Date: November 30, 2015

Subject: December 2015 Meeting Item 1—2015 Replacement Yield Signs near

Hammerschmidt Elementary School (Harrison Rd at Norbury Ave)

Stop and Yield Signage by Hammerschmidt School

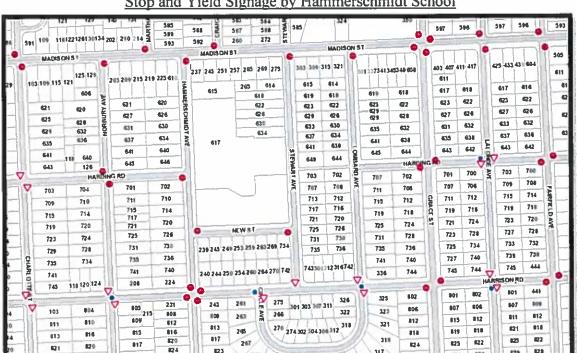
The Committee previously reviewed the below locations (shown with blue dots) to determine 2015 replacement needs for Yield signs by Hammerschmidt Elementary School.

The Committee agreed with the below staff recommendation except for Harrison Rd at Norbury Ave. The Committee chose to replace the Yield signs at this intersection with Stop signs. All intersections were previously reviewed for stop signs. Per MUTCD Sections 2B.04 and 2B.06, these intersections do not meet the required conditions for Stop signage. Unlike Stop signs, Yield signs do not have specific conditions for installation except that such signage should not be used for speed control. Removing such signage may present Village liability concerns for potential future incidents. Such policy has been reviewed and recommended by Public Works staff. Since all intersections have existing signage and do not meet stop sign conditions, the Village recommends retaining the Yield signs as shown for this and future intersection replacement.

Staff recommends no changes to the intersection signage.
